OAK POINTE CHURCH JSP23-21

Approval of the request of Oak Pointe Church, JSP23-21: Preliminary Site Plan for a building addition with a children's play area totaling approximately 1,000 square feet, and a patio addition. The subject parcel is in Section 20 of the city, east of Napier Road, west of Wixom Road, and north of Ten Mile Road. The property is zoned RA, Residential Acreage and the initial multiple phase site plan for the property was approved in 2001.

Oak Pointe Church Additions
JSP23-21

Oak Pointe Church Novi Additions Site Plan Review - Response Letter

2 ENLARGED LANDSCAPE PLAN
 SPA-5 1/8" = 1'-0"

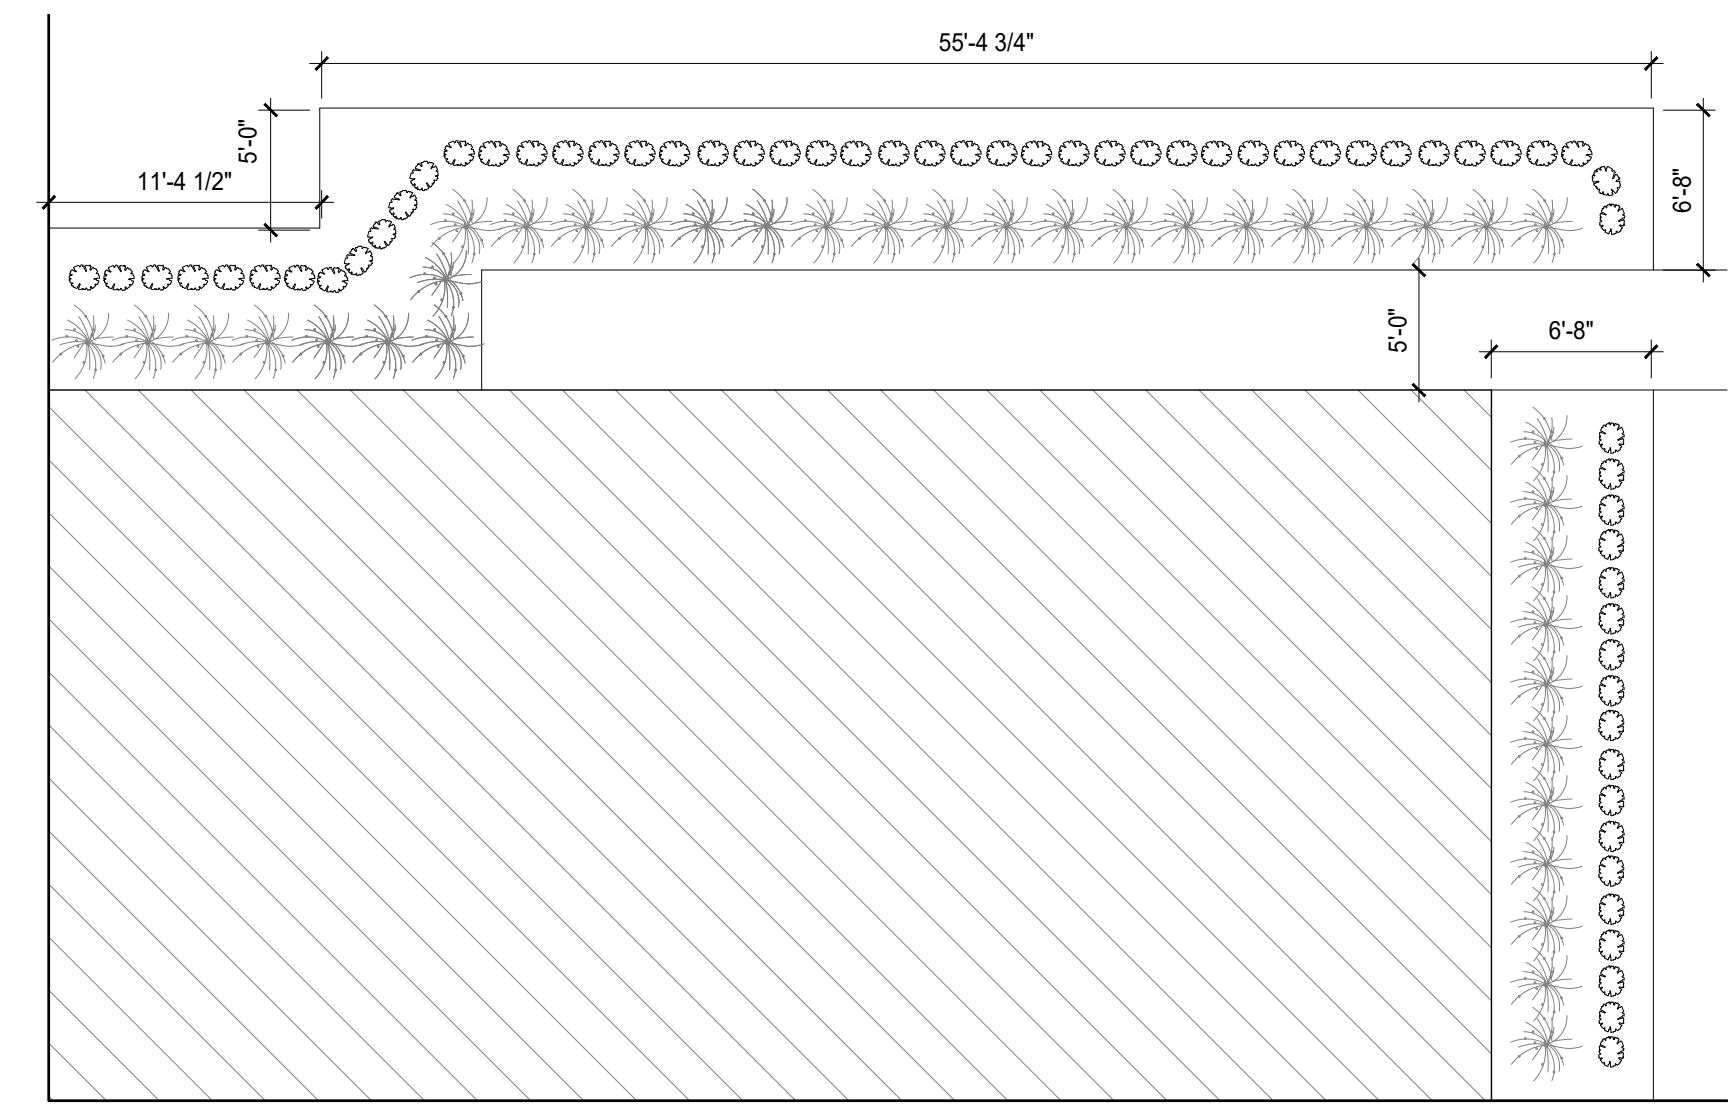
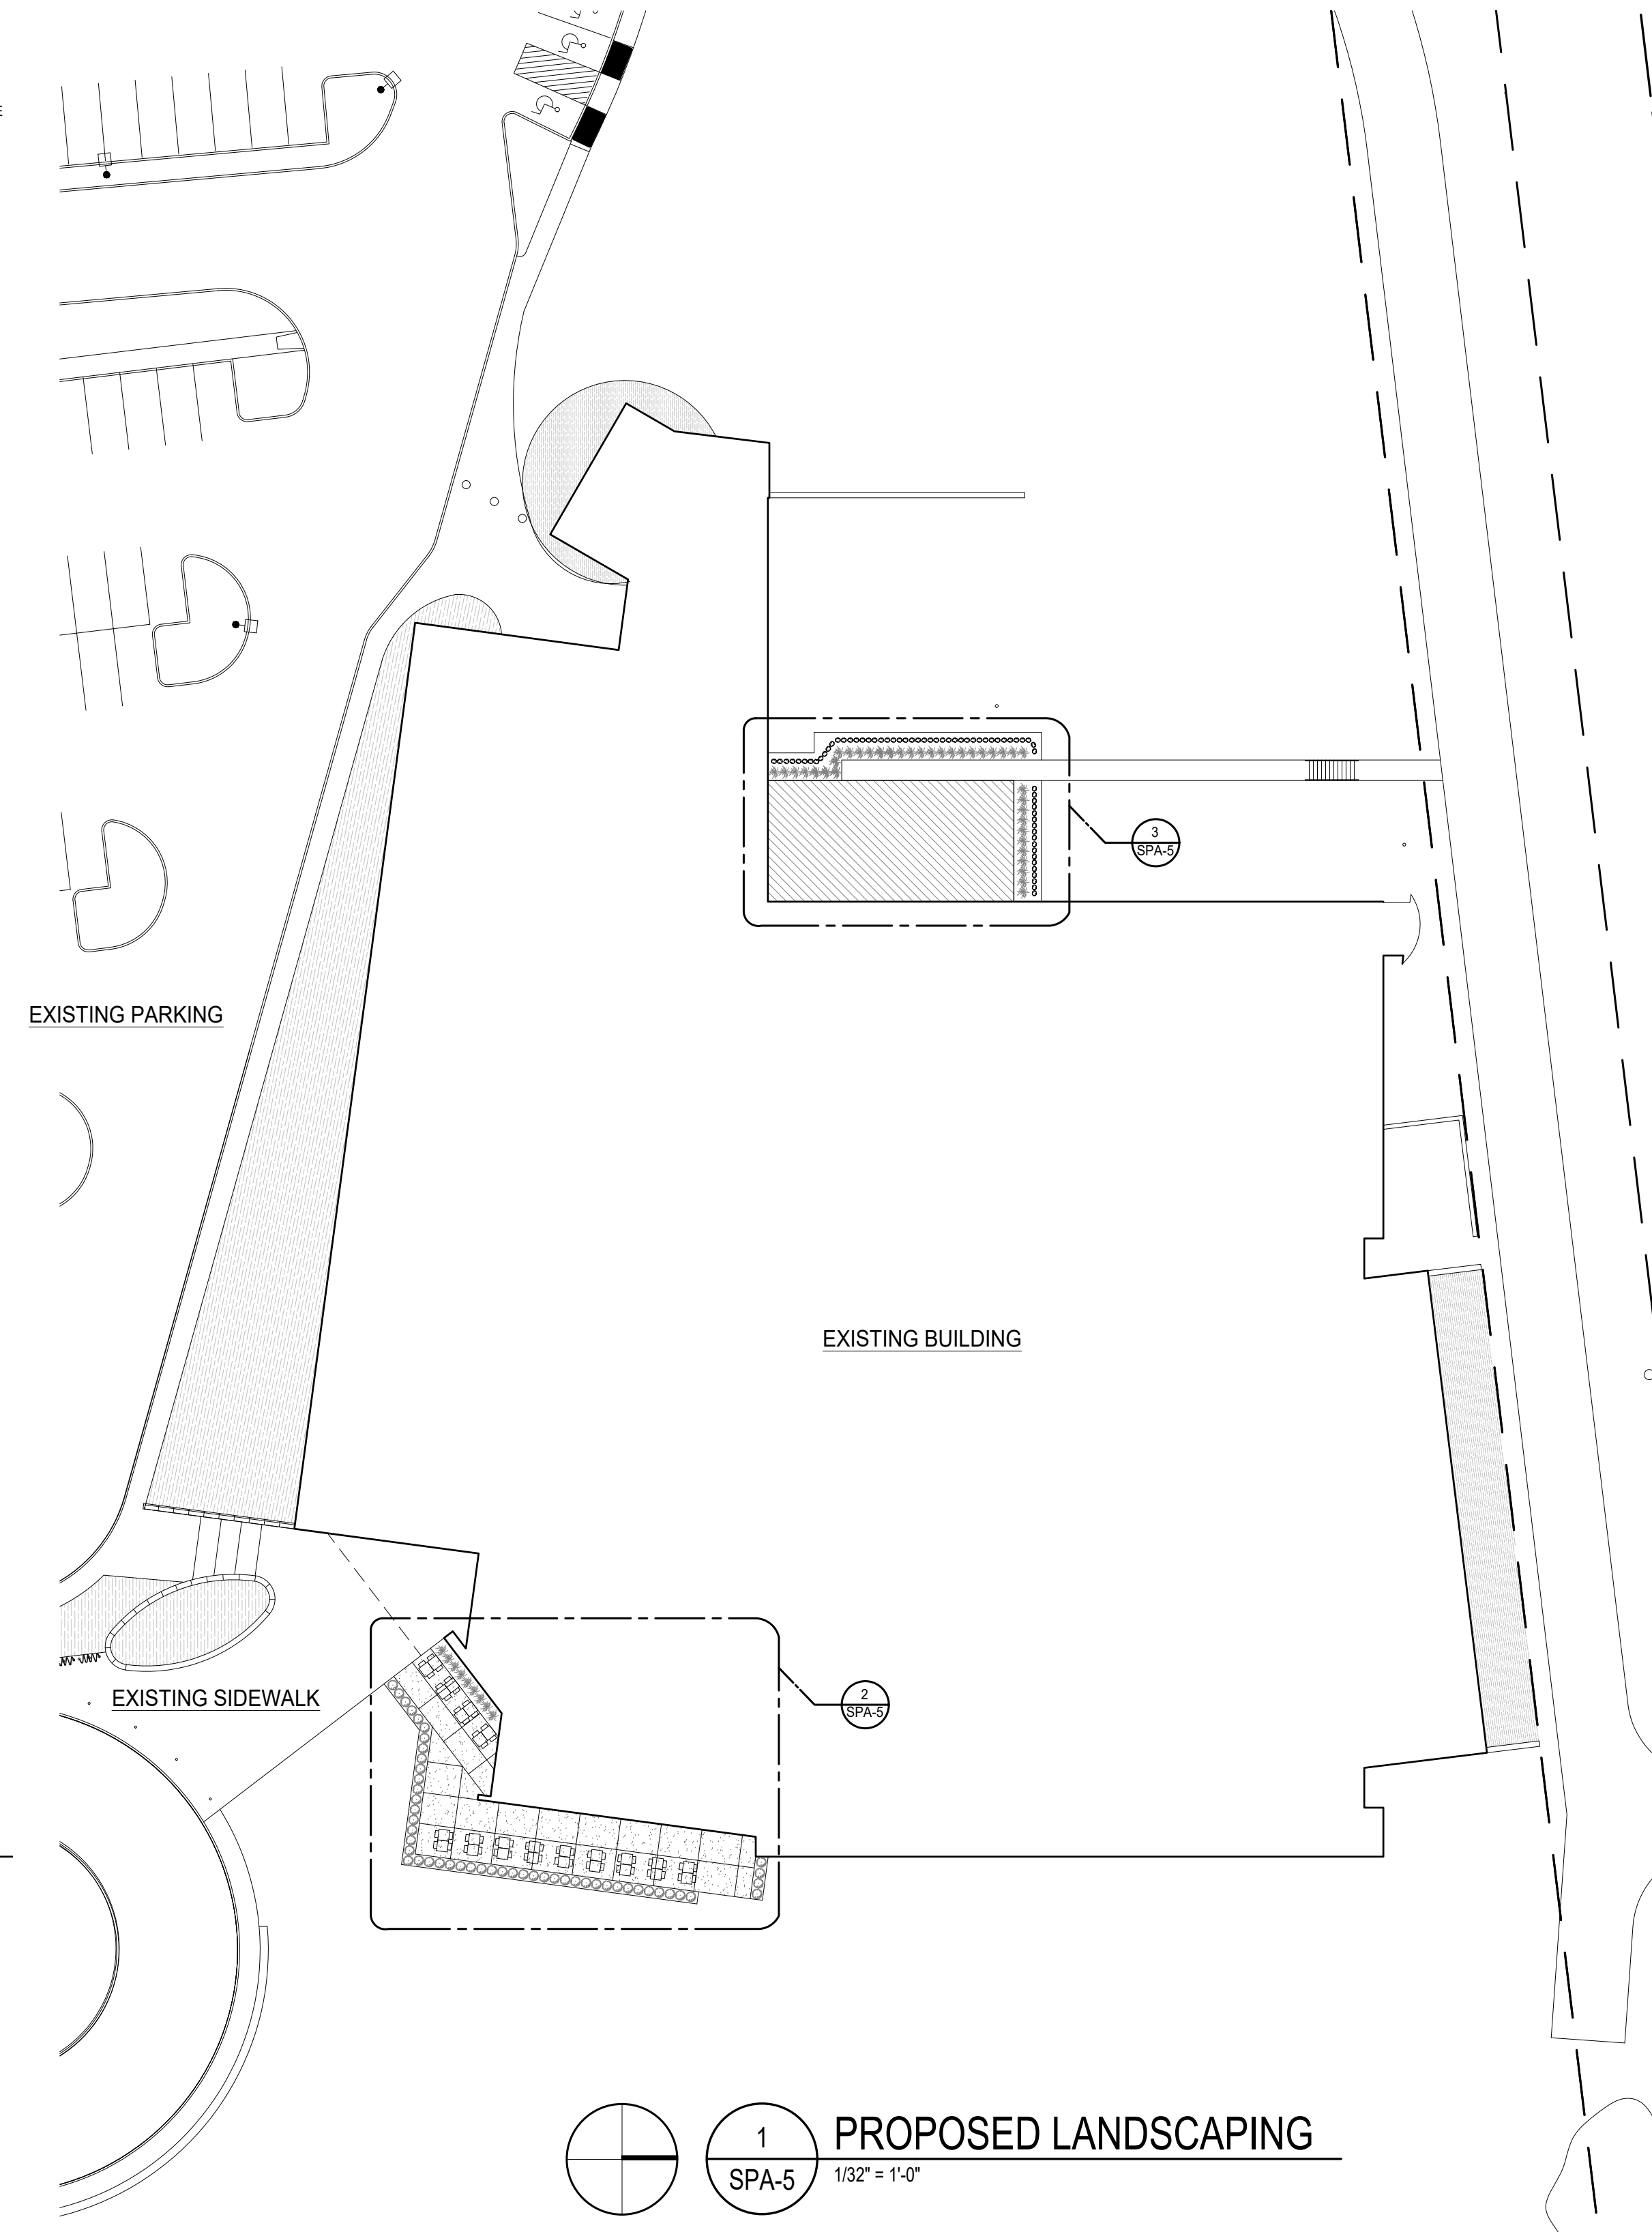
1. 668sf landscaping area is required around the foundation of the addition $(84.5)*8 = 676sf$, with a minimum width of 4 feet.
2. 256.5 sf is proposed and the landscape areas are only 3 feet wide. **This deficiency would require a landscaping waiver. It would not be supported by staff. Please add more area with a greater diversity of species used.**

1. Provided for the proposed boxwoods.
2. At least 50% of the species used must be native to Michigan. Please use a native shrub species for at least half of the shrubs shown on the plan. Flowering/fruited shrub species that provide food for pollinators and birds would be especially appreciated.

- Area has been increased to 685 SF to comply with requirements and landscaping has been revised to vary species.

- 100% of the plants surrounding the addition have been revised to be plants native to Michigan.
